Technical Service Information

CHRYSLER A500/518

PREMATURE OVERDRIVE CARRIER FAILURE

Figure 1

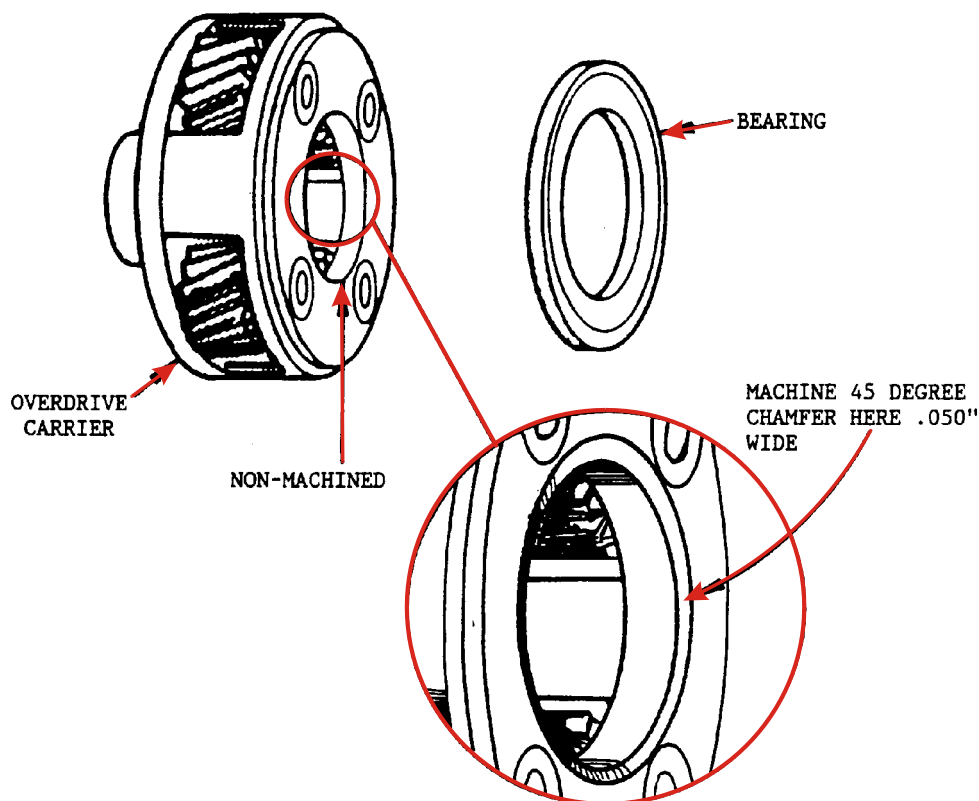
COMPLAINT: Premature failure of overdrive carrier and bearing. The bearing is actually destroyed first and the bearing takes out the overdrive carrier.

CAUSE: The cause is lack of lube oil to the carrier bearing.

CORRECTION: Replace the bearing and overdrive carrier. BEFORE installing the new overdrive carrier, machine a chamfer on the inside diameter that is .050" wide as shown in Figure 1. This will provide more lube oil for the carrier bearing.
